ARKEMA EARLY ACTION
EE/CA WORK PLAN

Work Plan Addendum

July 22, 2008

Figure 9-1. Project Schedule

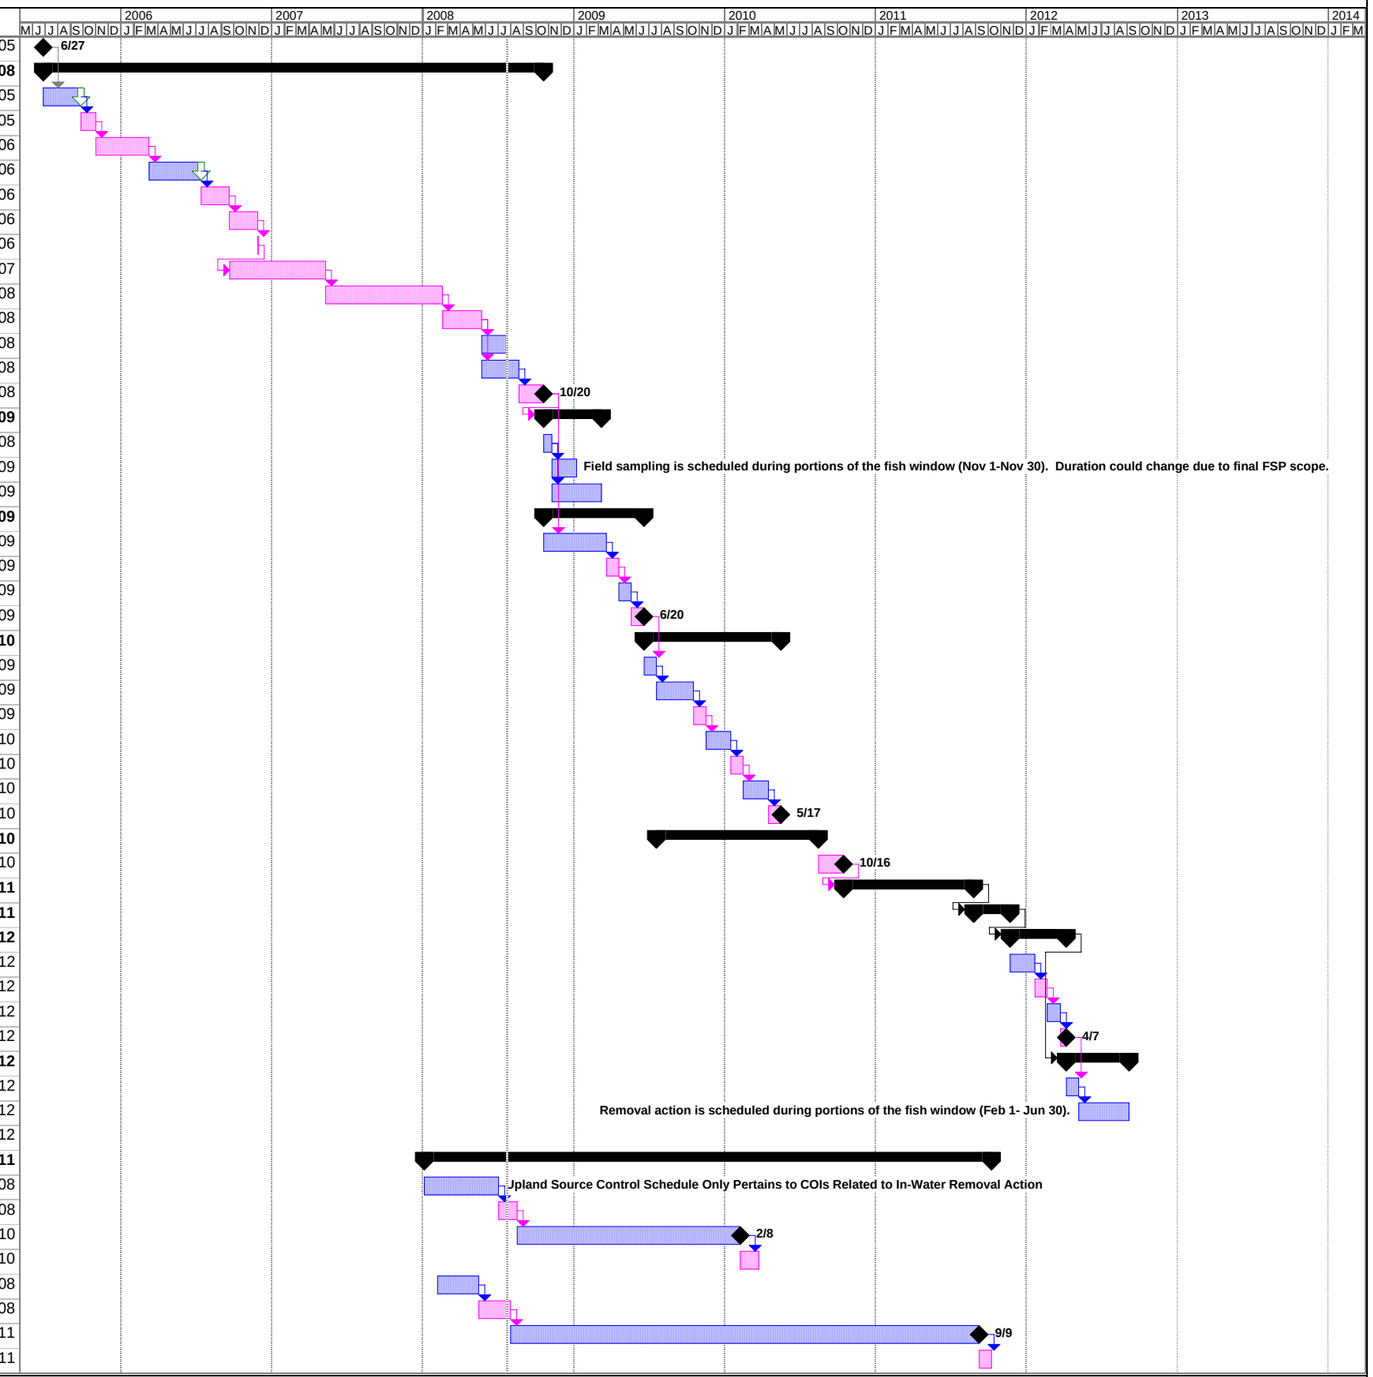
Removal action activities are on schedule and will be completed within the timeline provided in the Statement of Work (SOW) and in accordance with the AOC. Addendum Figure 9-1 updates the current project schedule, as modified by the Opalski Decision.
